SERVICE BULLETIN

APPLICABILITY: 2010-2014MY Legacy and Outback Models

NUMBER: 12-166-14

SUBJECT: Revised L/Front Dash Speaker Grille

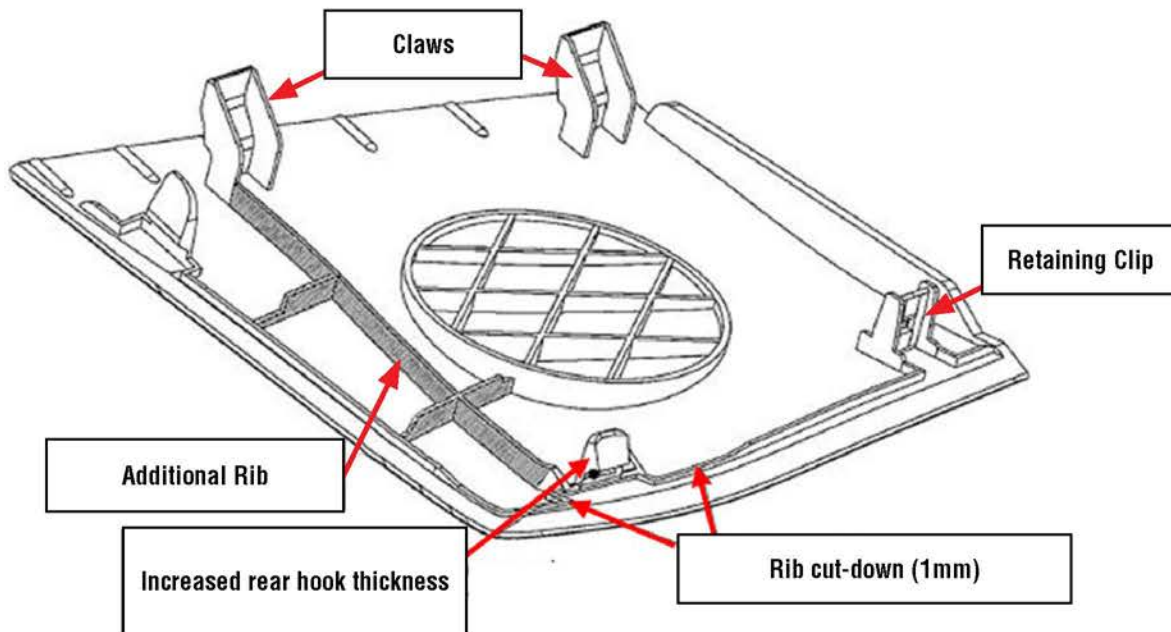
A design change has been made to the retaining hook and reinforcement rib portions of the left front dash speaker grille to increase retention and maintain proper fit to the dashboard trim.

The new speaker grille was incorporated into production during October, 2013 starting with the following VINs: Legacy- **E*015842** and Outback- **E*240453**.

PART NAME	NEW PART NUMBER
GRILLE-SPEAKER, SIDE	66119AJ06A
